Red Clay Consolidated School District
AI DuPont Middle School HVAC Renovations
Bid Pac "A"

ADDENDUM #1 ISSUED BY EDiS COMPANY
110 S. POPLAR STREET, WILMINGTON, DE 19801

PARTIAL SECOND FLOOR NEW RCP - AREA B - 1/A3.12

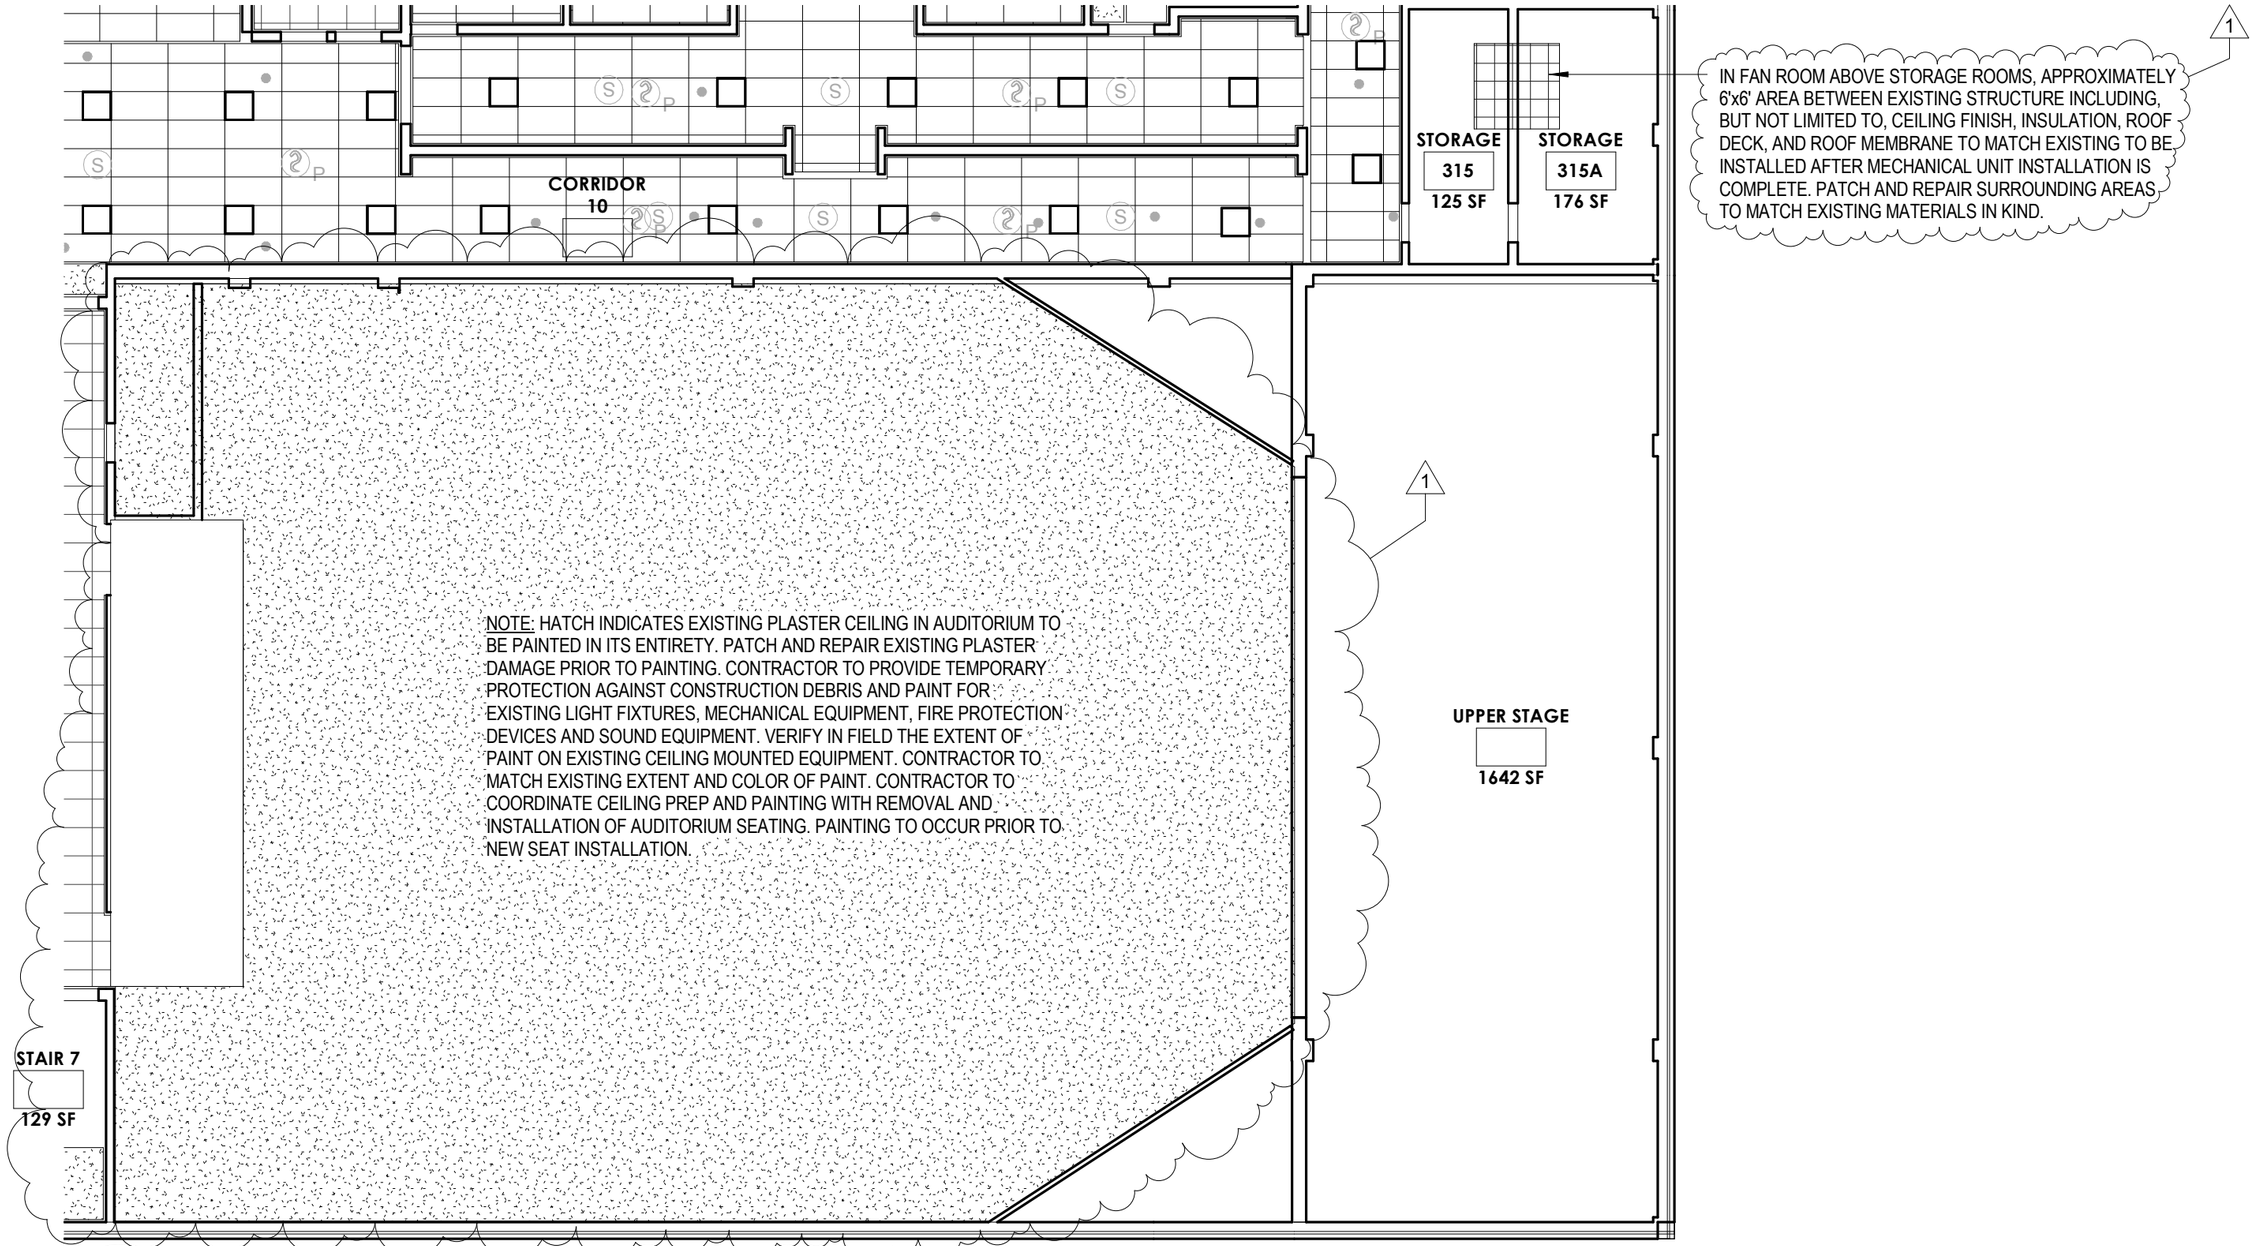
12. Drawing A3.12 – Add painting of Auditorium ceiling to scope of work. See sketch SK-A.10.
13. Drawing A2.5 – Add partial demolition of existing partition for new electrical panel. See sketch SK-A.11.

PARTIAL SECOND FLOOR PLAN - AREA A - 1/A3.5

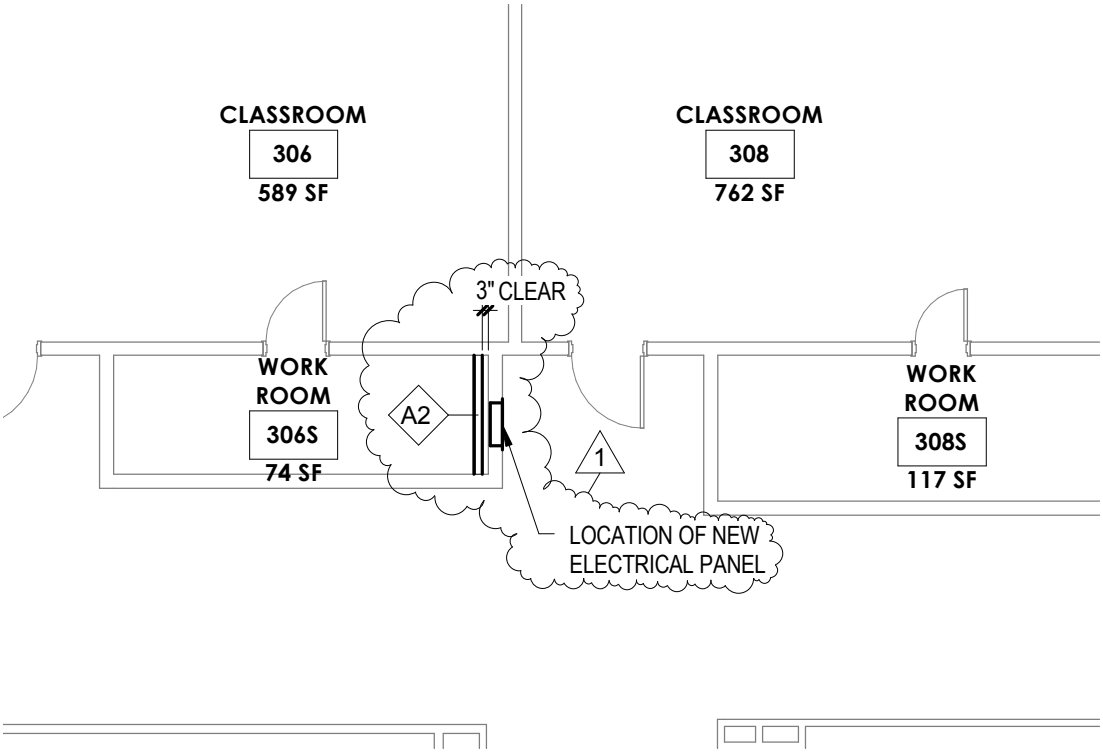
14. Drawing A3.5 – New partition wall added to Work Room 306S behind corridor partition wall where new electrical panel to be installed. See sketch SK-A.12.

PARTIAL LOWER LEVEL DEMOLITION PLAN - AREA B - 1/A2.2

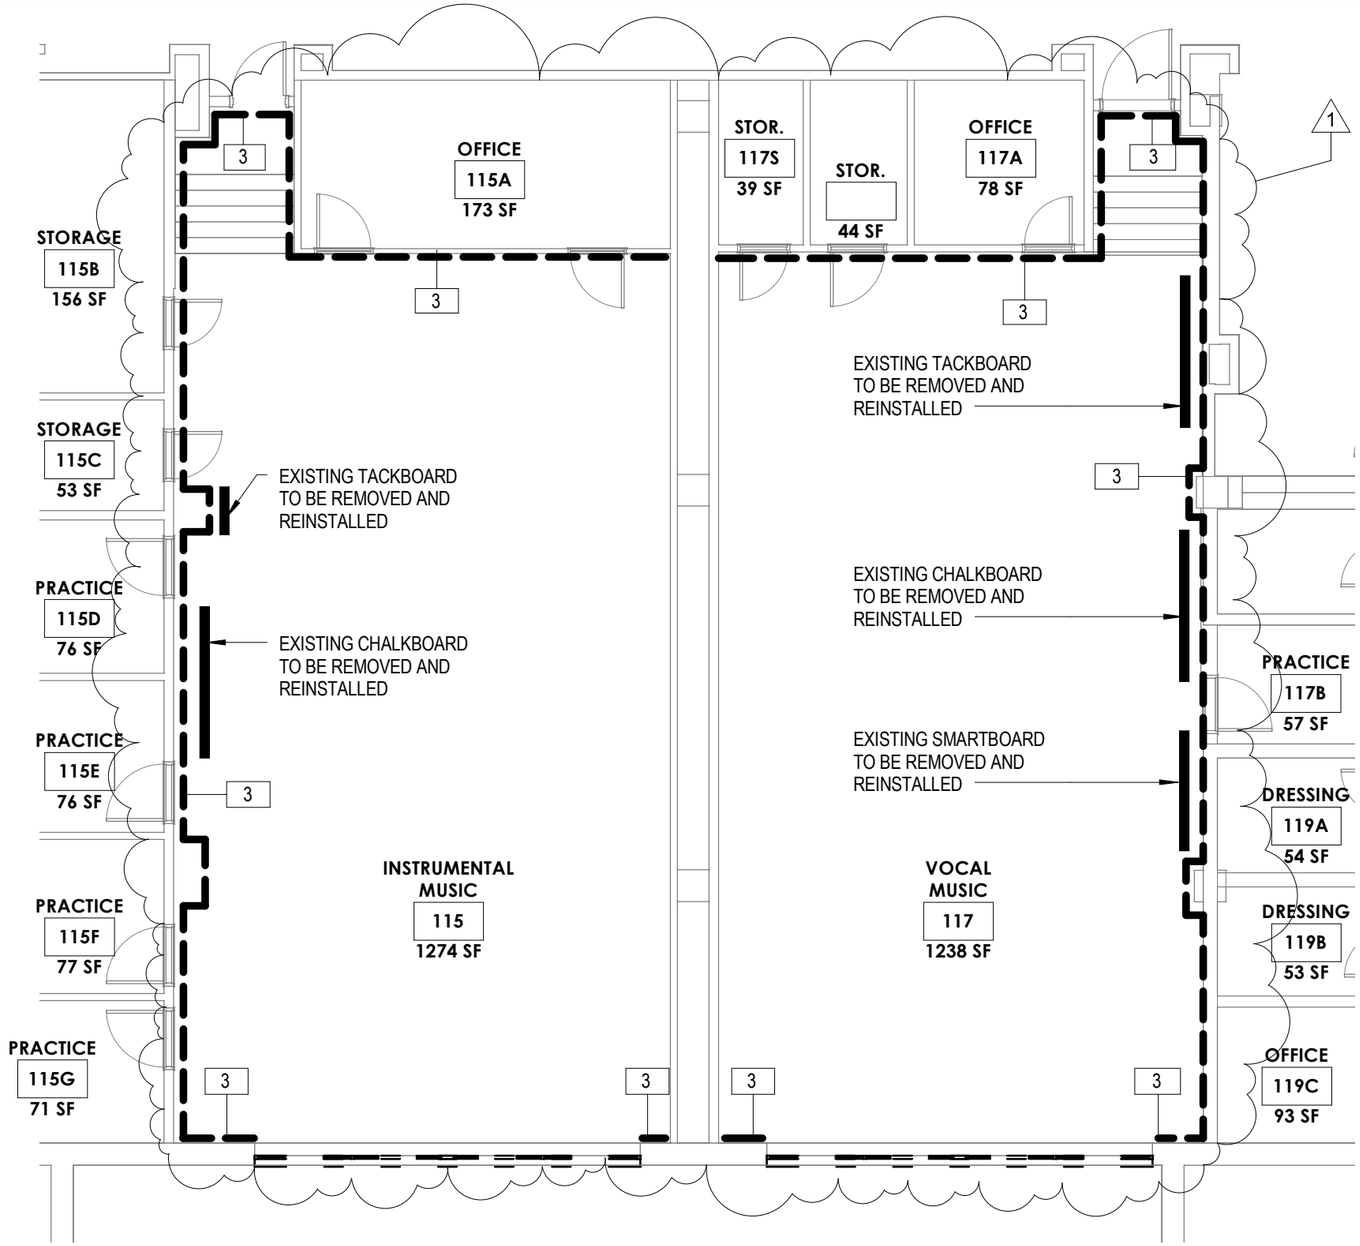
15. Drawing A2.2 – Revision made to location of existing acoustical wall panels in rooms 115 and 117. See sketch SK-A.13.
16. Drawing A3.2 – Revision made to location of new acoustical wall panels in rooms 115 and 117. See sketch SK-A.14.

PARTIAL FIRST FLOOR DEMOLITION PLAN - AREA A - 1/A2.3

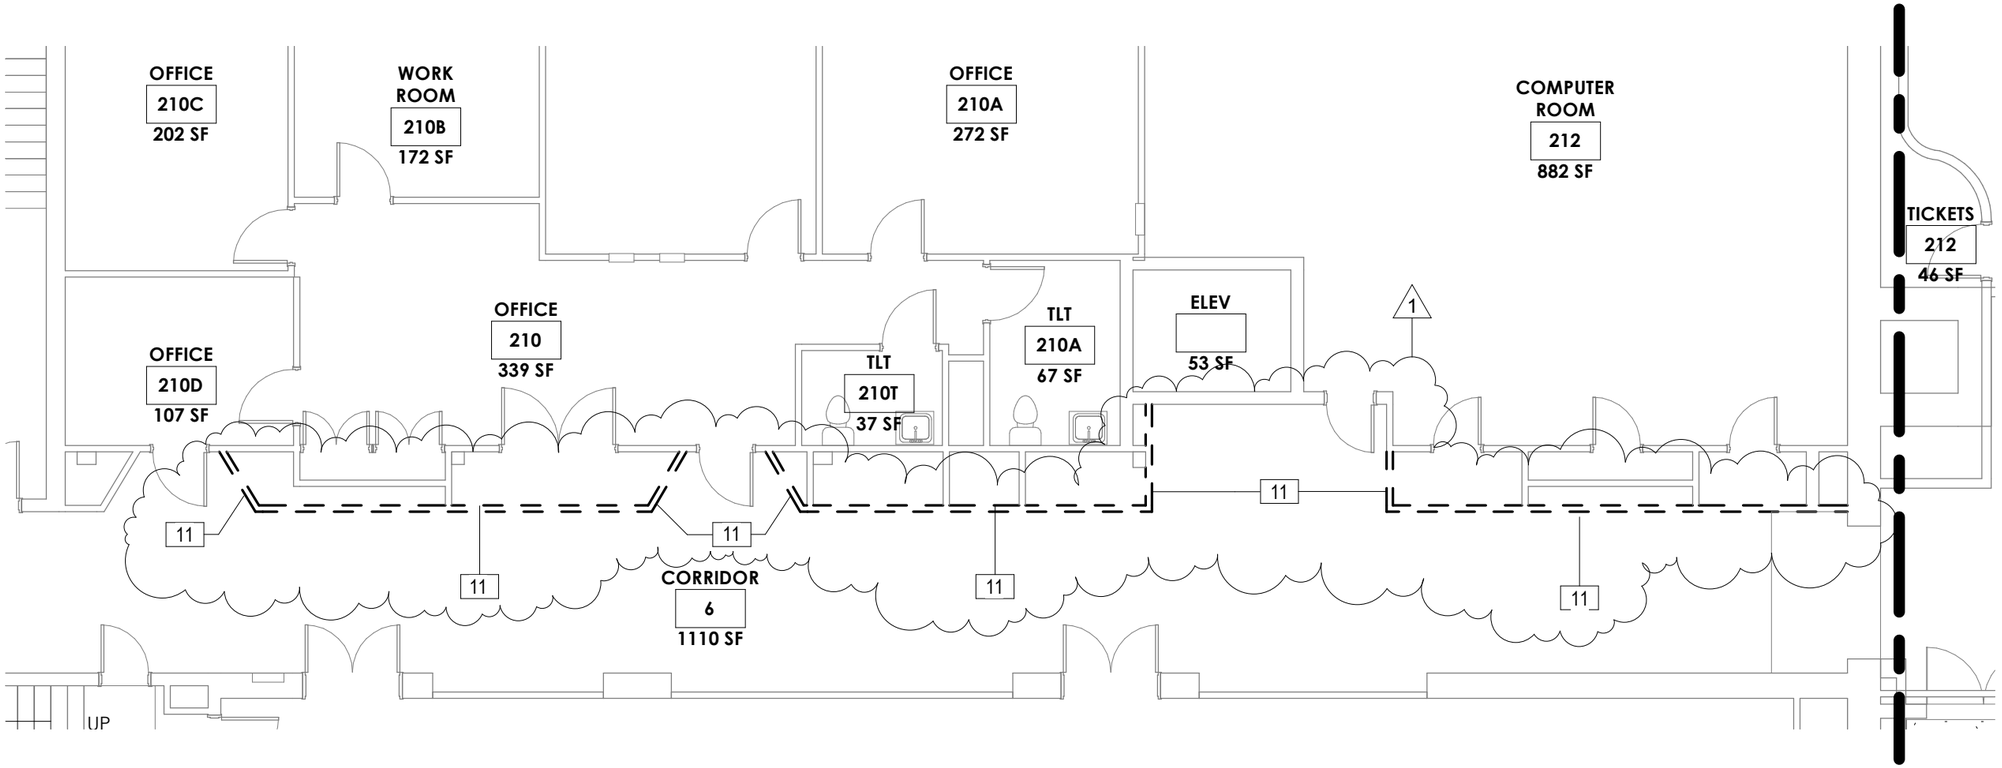
17. Drawing A2.3 – Add demolition of existing corridor partitions to scope of work. See sketch SK-A.15.
18. Drawing A2.4 – Revision to keynote on existing door to be demolished in SAC Room 216. Add demolition of masonry at existing chimney chase to scope of work. See sketch SK-A.16.

PARTIAL SECOND FLOOR DEMOLITION PLAN - AREA A - 1/A2.5

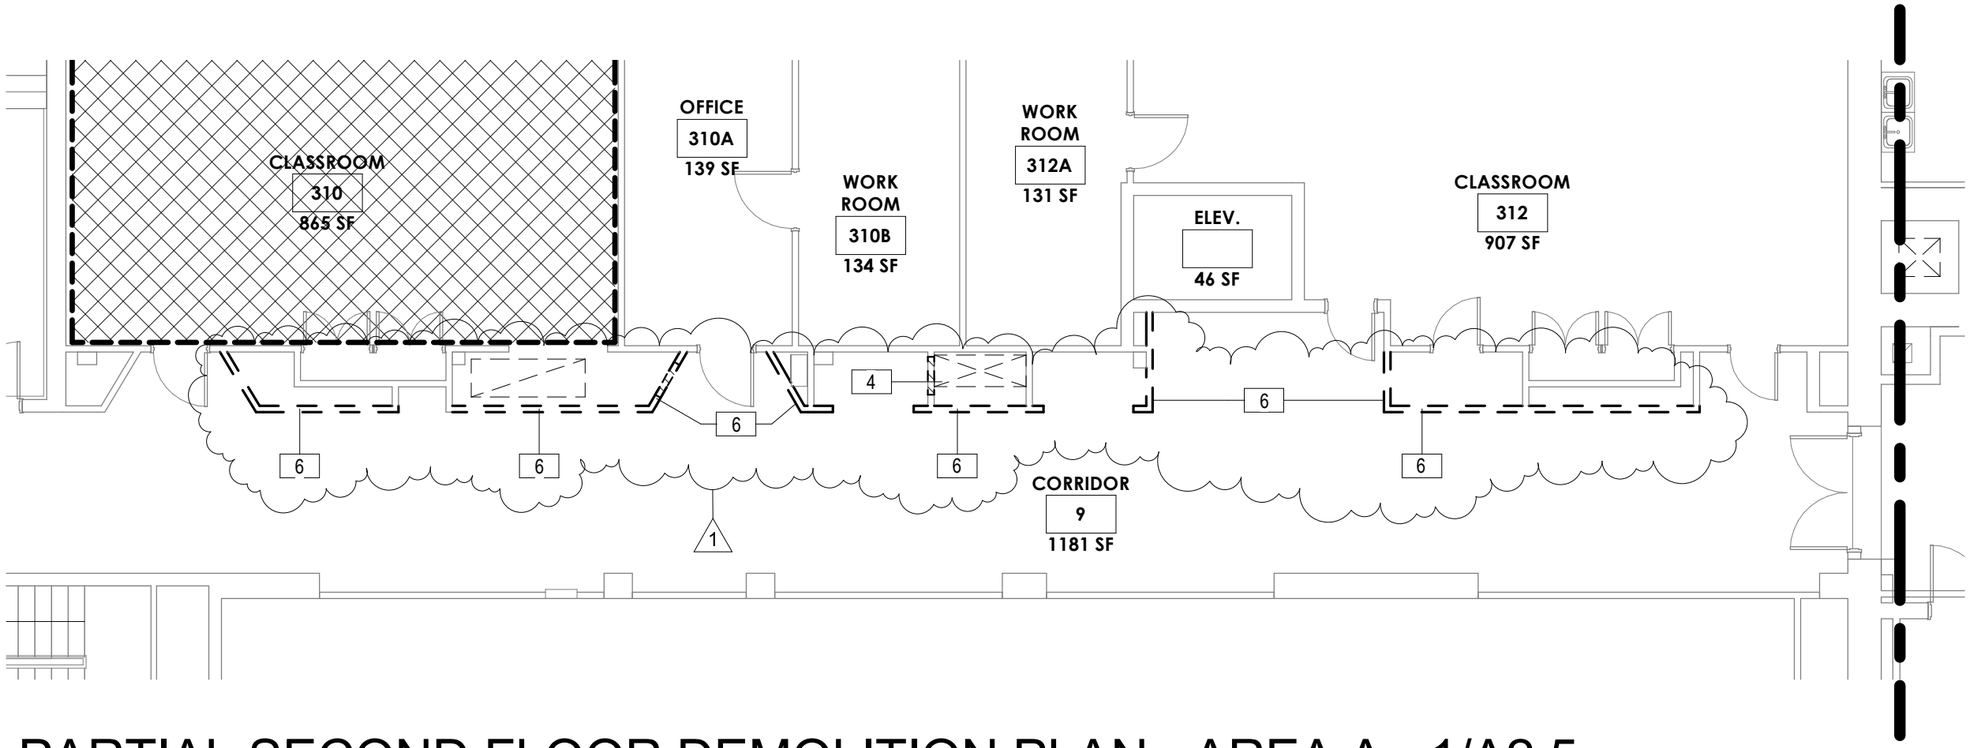
19. Drawing A2.5 - Add demolition of existing corridor partitions to scope of work. See sketch SK-A.17.
20. Drawing A2.6 - Add demolition of masonry at existing chimney chase to scope of work. See sketch SK-A.18.

PARTIAL LOWER LEVEL PLAN - AREA B - 1/A3.2

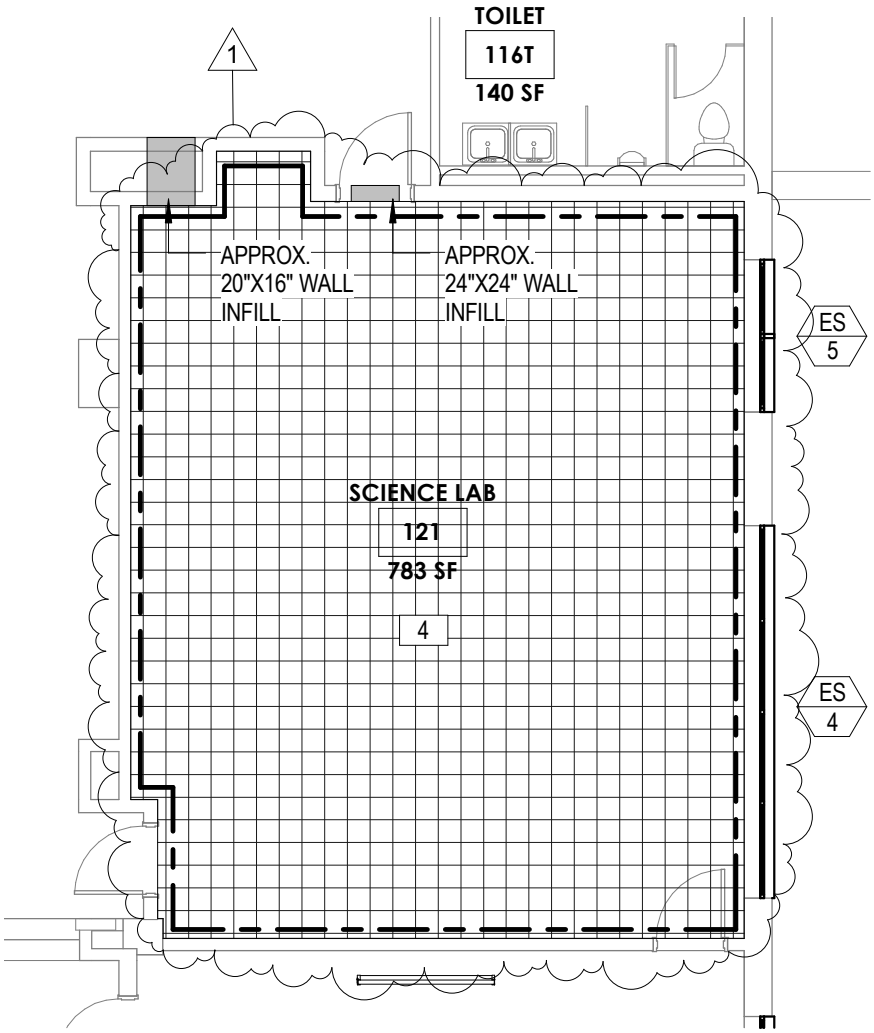
21. Drawing A3.2 – Floor hatch added to plan for clarification. See sketch SK-A.19.
22. Drawing A3.3 – Add new walls at corridor where existing walls are to be demolished. See sketch SK-A.20.

PARTIAL SECOND FLOOR PLAN - AREA A - 1/A3.5

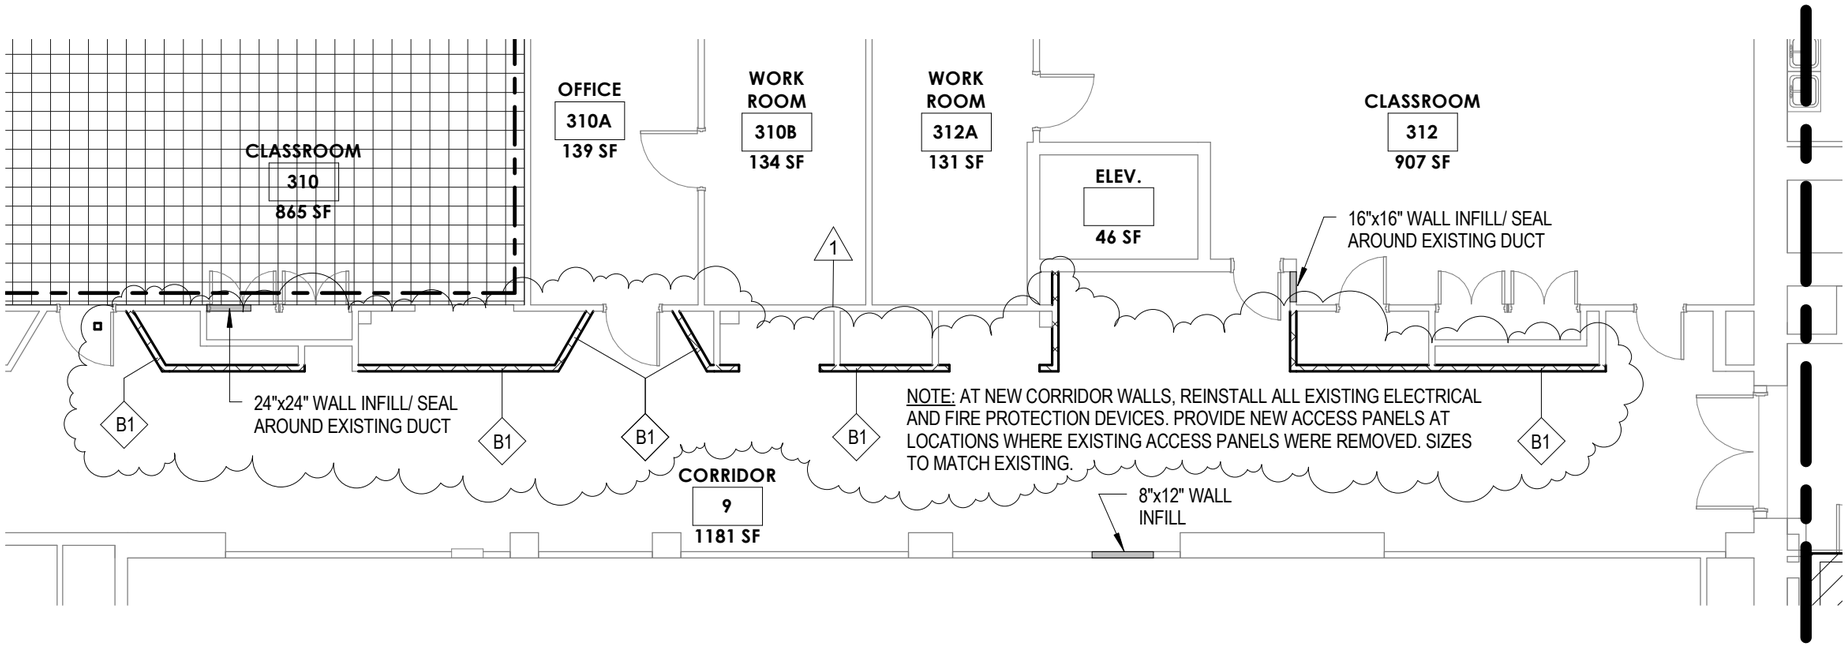
23. Drawing A3.5 – Add new walls at corridor where existing walls are to be demolished. See sketch SK-A.21.
